# Delaware Street Rehabilitation Construction Phase

## City Council Meeting

September 10, 2019

# OPTION 1

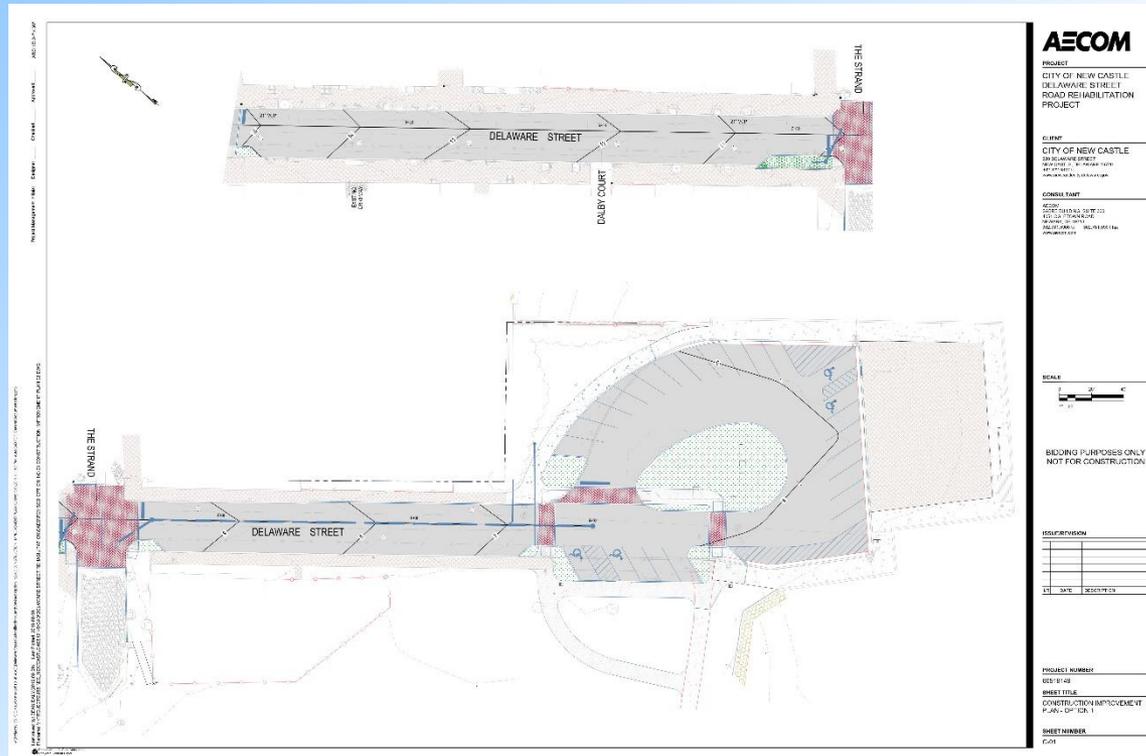
- No Road Widening from 2<sup>nd</sup> Street to the Wharf
  - Deduct Approximately \$50,000 from Bid Price
  - Reduce MSC's costs for materials

# OPTION 2A

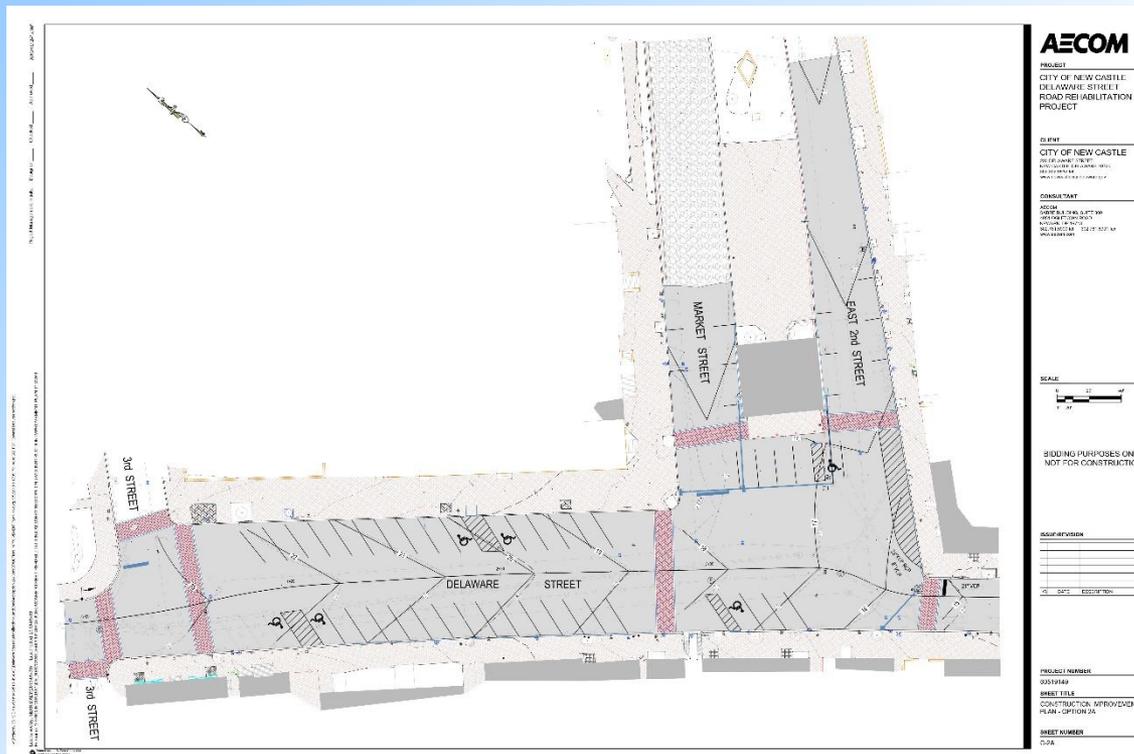
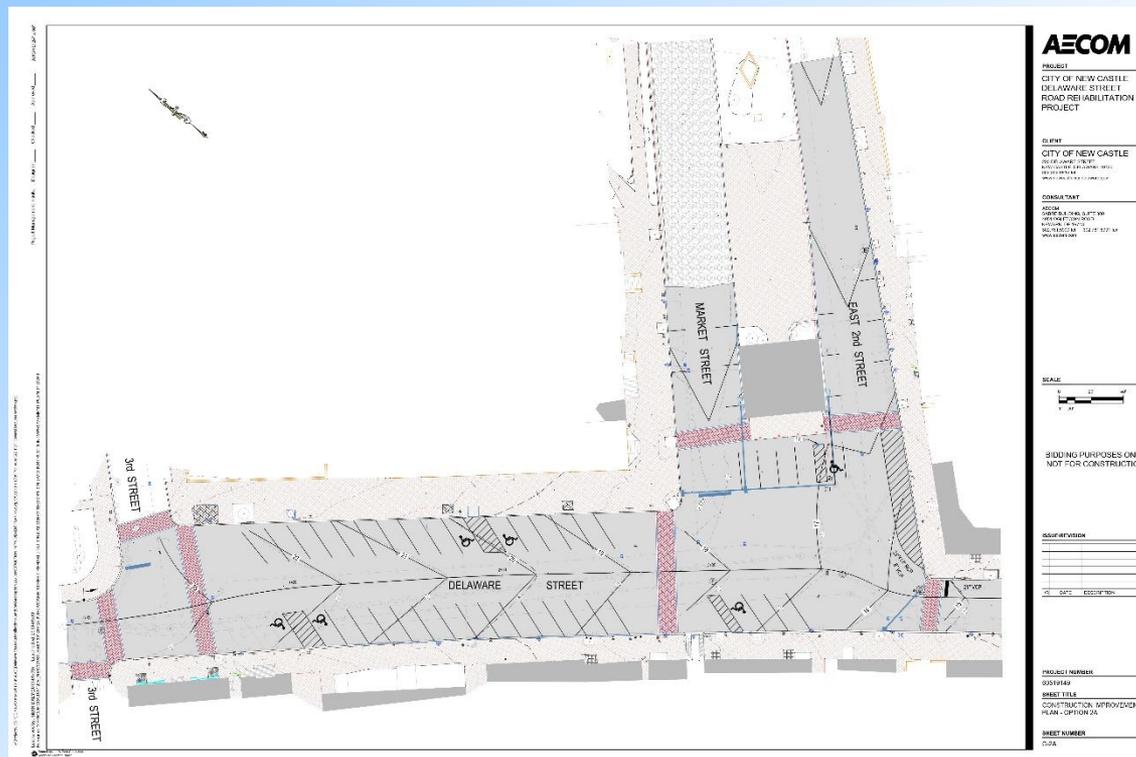
- No Bump Outs and Extend Brick Crosswalks
  - Reduction in new granite curbs and new brick sidewalks
  - No bioretention for stormwater quality treatment
  - Higher paving and brick crosswalk costs

- No Bump Outs and Extend Brick Crosswalks
  - Deduct Approximately \$150,000 from Bid Price

# OPTION 2B

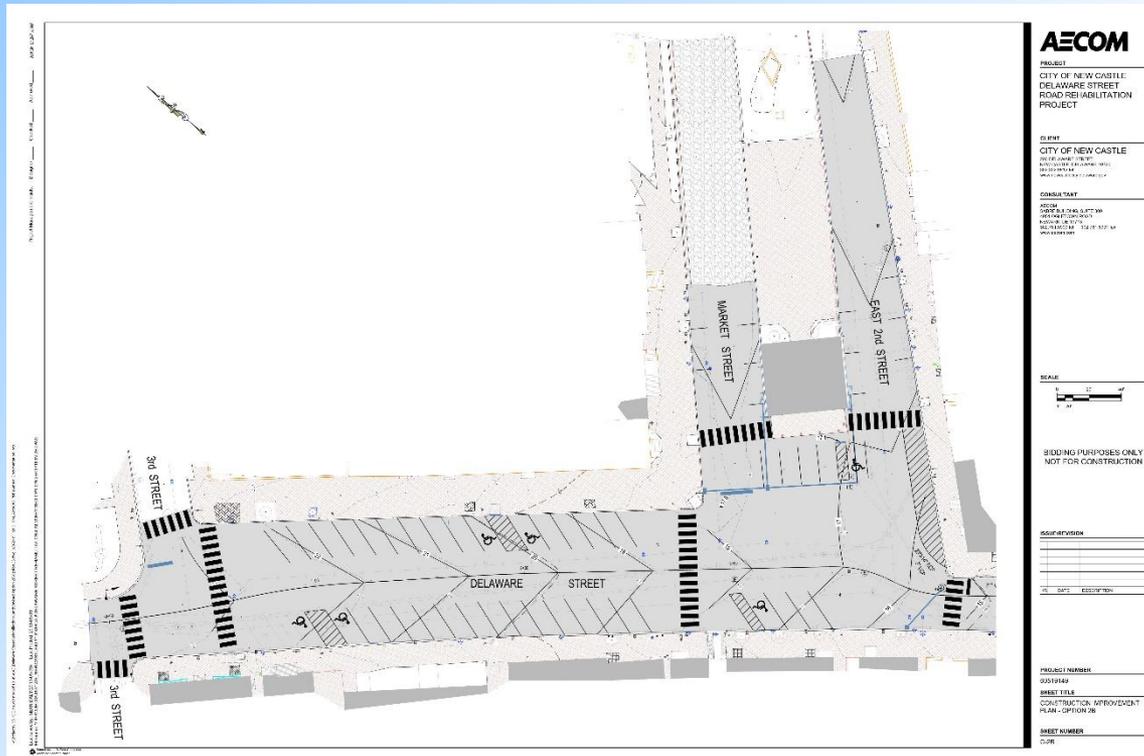
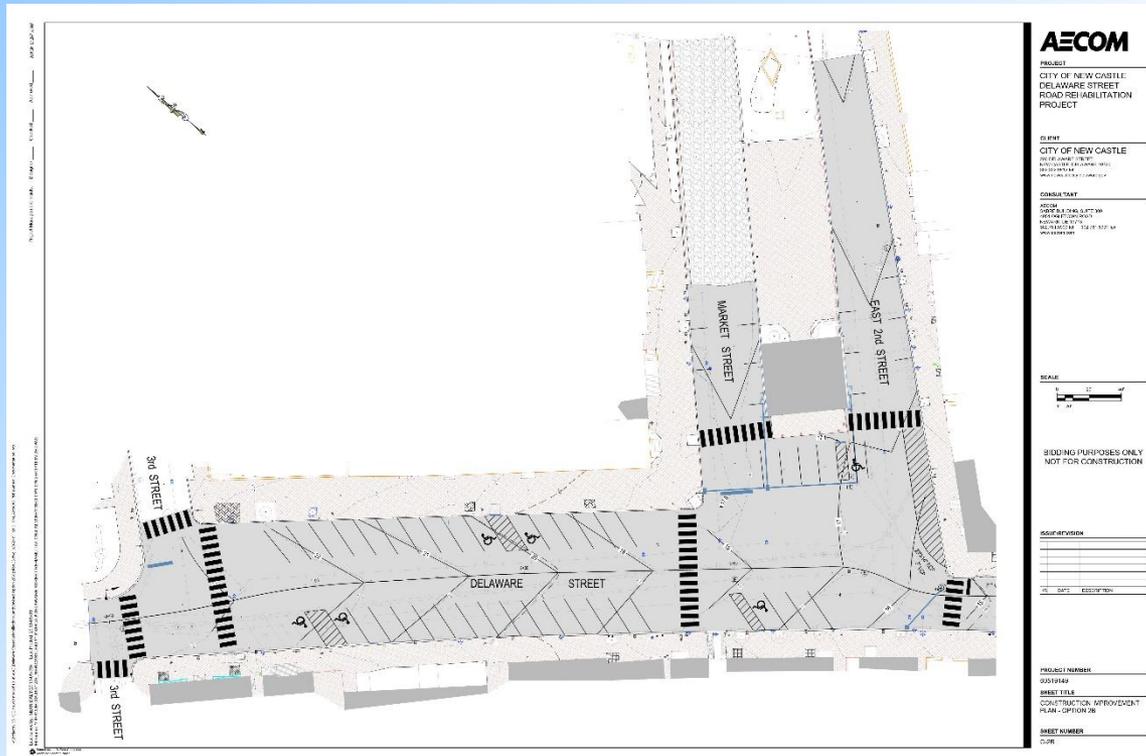
- No Bump Outs and No Brick Crosswalks
  - Reduction in new granite curbs, brick sidewalks and crosswalks
  - No bioretention for stormwater quality treatment
  - Higher paving costs and need alternate for crosswalks

- No Bump Outs and No Brick Crosswalks
  - Deduct Approximately \$400,000 from Bid Price
